SUNDRY NOTICES AND REPORTS ON WELLS

Yates Petroleum Corporation plans to plug and abandon this well as follows:

WELL NAME: Lechuguilla Canyon DK #1 FIELD: Crooked Creek Morrow
 LOCATION: 1,980' FSL & 2,130' FEL of Section 3-24S-24E Chaves Co., NM
 GL: 3,850 ZERO: KB: 3,865
 SPUD DATE: 11/28/04 COMPLETION DATE:
 COMMENTS: API No.: 30-005-63689

WELL NAME: Lechuguilla Canyon DK #1

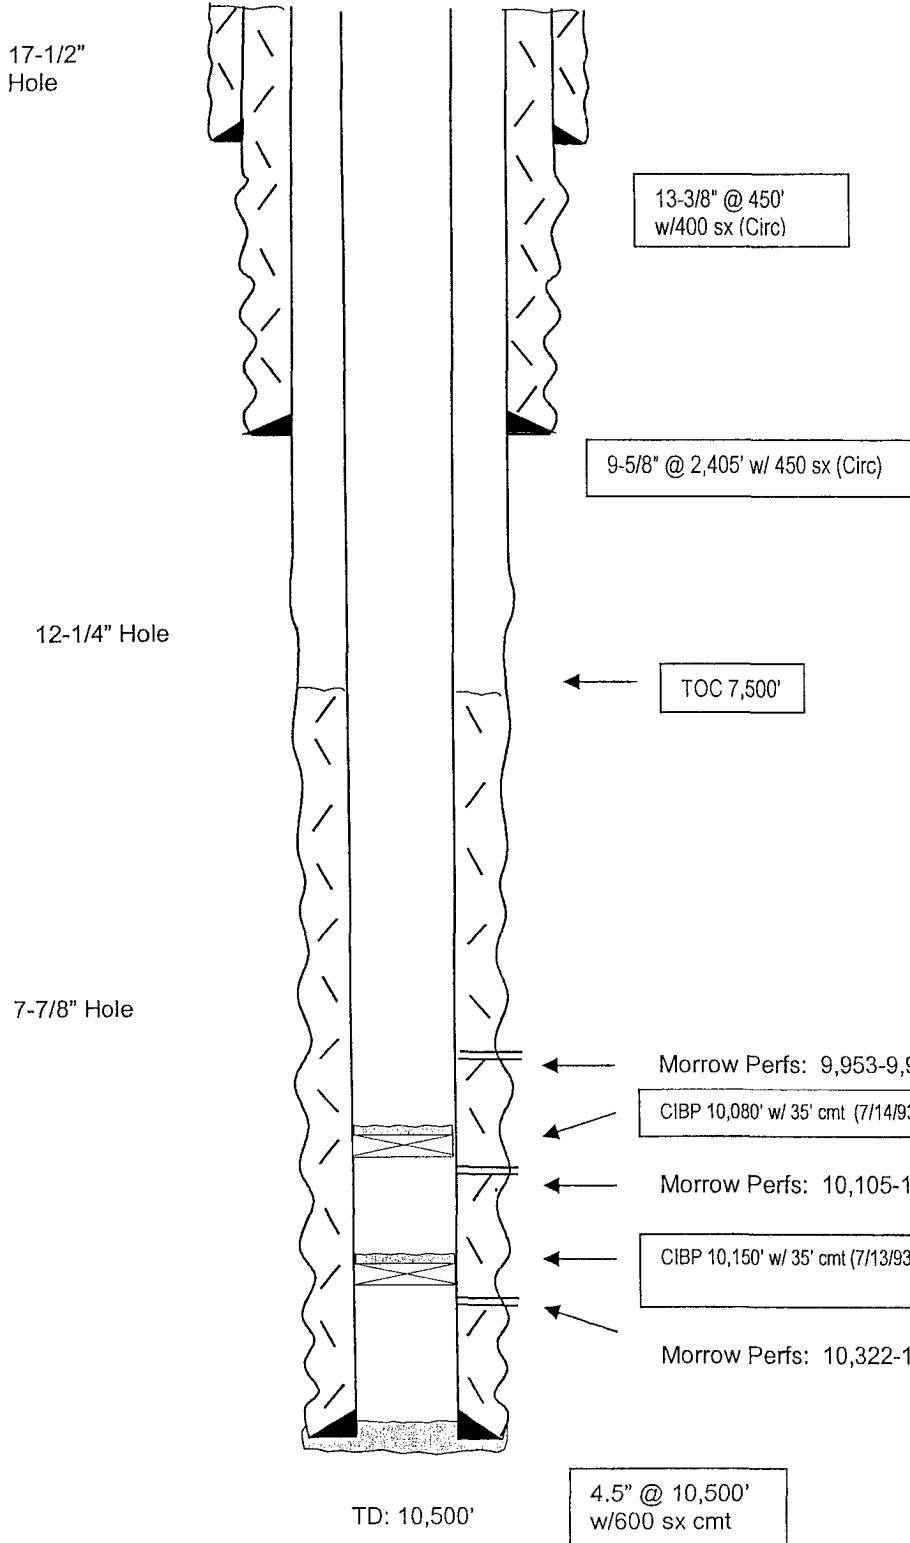
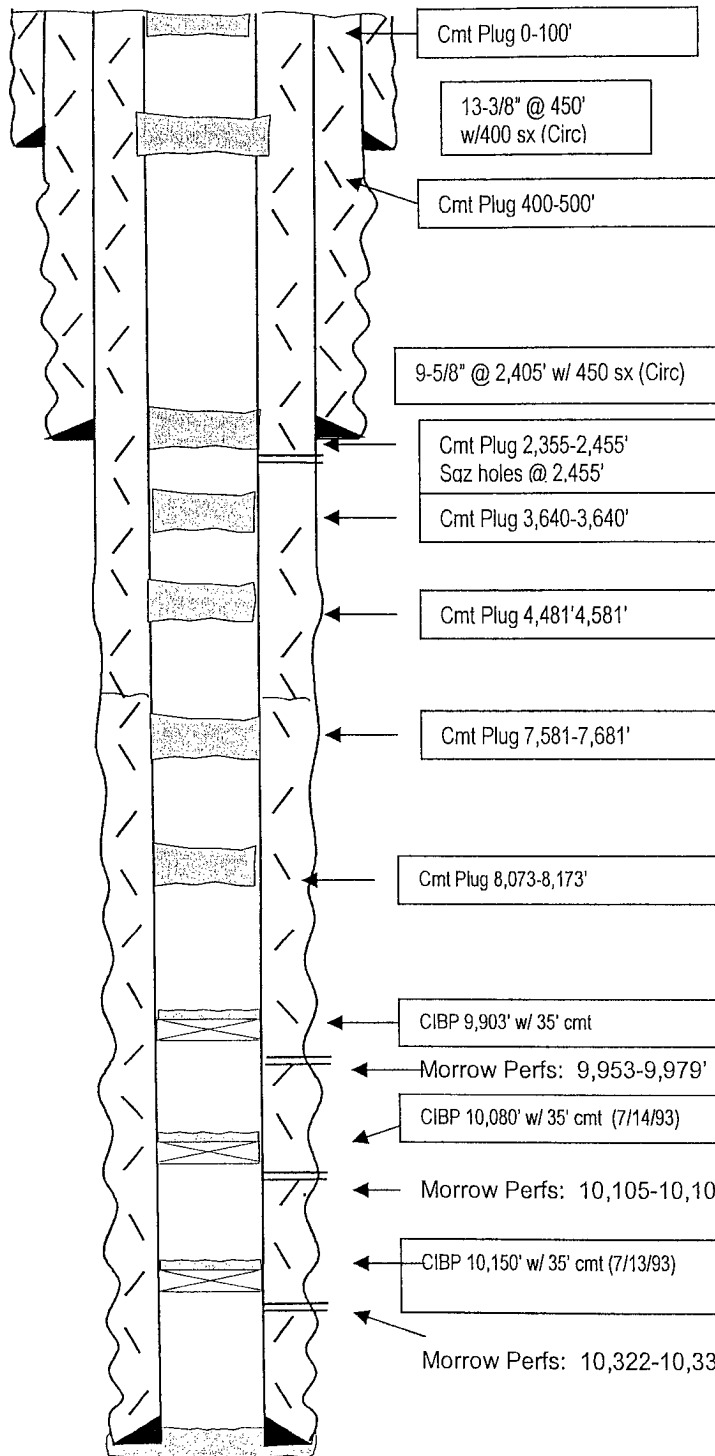
1. RIH with gauge ring and junk basket to +/-9910'.
2. Set a 4-1/2" CIBP at 9903' with 35' cement on top.
3. Spot 100' cement plug (10 sx) across the Canyon from 8073'-8173'.
4. Spot 100' cement plug (10 sx) across the Wolfcamp from 7581'-7681'.
5. Spot 100' cement plug (10 sx) from 4481'-4581'.
6. Spot 100' cement plug (10 sx) across the Bone Spring from 3640'-3740'. POOH laying down all but 2355' of tubing.
7. Perforate squeeze holes at 2455'.
8. Spot 100' cement plug (estimate +/-1510 sx) from 2355'-2455' inside and outside the casing. Tag plug.
9. Spot 100' cement plug (10 sx) from 400'-500'. Tag plug.
10. Spot 100' cement plug (10 sx) from 100' to surface. Tag plug.
11. Cut off wellhead and install dry hole marker as per regulated.

1. Approval is granted to P/A this well with the following modifications to the program:
2. The cement on top of the CIBP must be tagged.
3. The casing must be perforated and squeezed for the plugs @ 2455', 500' and 100' leaving at least 25 sack of cement inside the casing. In the case of the plugs @ 500' and 100'; these plugs can be combined into one plug, however the annulus must be cemented to the surface.

*** All plugs, including the surface plug, should be at least 25 sacks of cement and 100 feet.**
